Access Compliance Report Public Rights-of-Way (Curb Ramps)

Main Street: ALLEGHENY_DR Cross Street: BOW_PL Location: NE

ADA ID: RPAT211025093318 Ramp Type: Type 6 - Directional 1 Initial Pass/Fail: Fail Overall Compliance: No Severity Score: 5

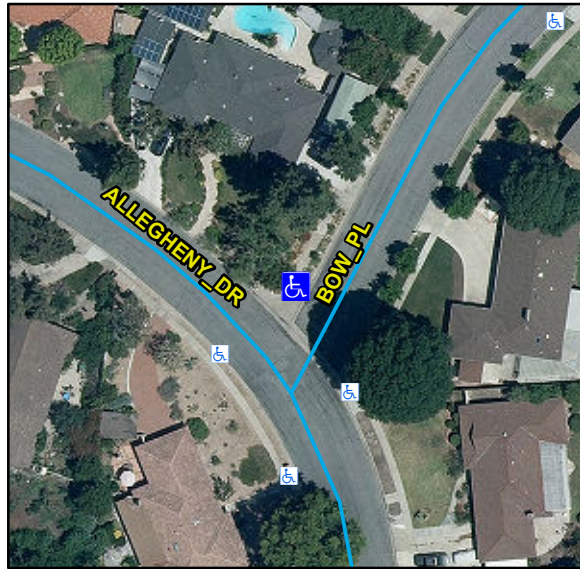
Compliance	Description	Data	Compliance	Description	Data
N/A	Ramp Length (in)	119	N/A	Flare Type LT	
No	Ramp Width (in)	46			N/A
Yes	Ramp Run Slope (%)	7.9	N/A	Flare Slope LT (%)	N/A
No	Ramp Cross Slope (%)	2.6	N/A	Flare Traversable LT	N/A
N/A	Grade Break	N/A	N/A	Flare Type RT	
N/A	Grade Break Slope (%)	N/A			N/A
N/A	Grade Break Cross Slope (%)	N/A	N/A	Flare Slope RT (%)	N/A
	Addl Para Ramp Left?	No	N/A	Flare Traversable RT	N/A
	Addl Para Ramp Right?	No	N/A	DWS Provided	N/A
N/A	Landing Present	N/A	N/A	DWS Contrast	N/A
N/A	Landing Length (in)	N/A	N/A	DWS Length (in)	N/A
N/A	Landing Width (in)	N/A	N/A	DWS Full Width	N/A
N/A	Landing Run Slope (%)	N/A		DWS Offset Type	N/A
N/A	Landing Cross Slope (%)	N/A	N/A	DWS Left Offset (in)	N/A
N/A	Landing Movement Obstructed?	N/A	N/A	DWS Right Offset (in)	N/A
	Landing Movement Type	N/A			
N/A	Landing Shared	N/A			
N/A	Marked Crosswalk 1	No	N/A	Clear Space	Yes
	Crossing 1 Direction	SW	N/A	Clear Space To Crosswalk (in)	N/A

Remove & Replace Curb Ramp With Two New Directional Ramps or Equivalent.
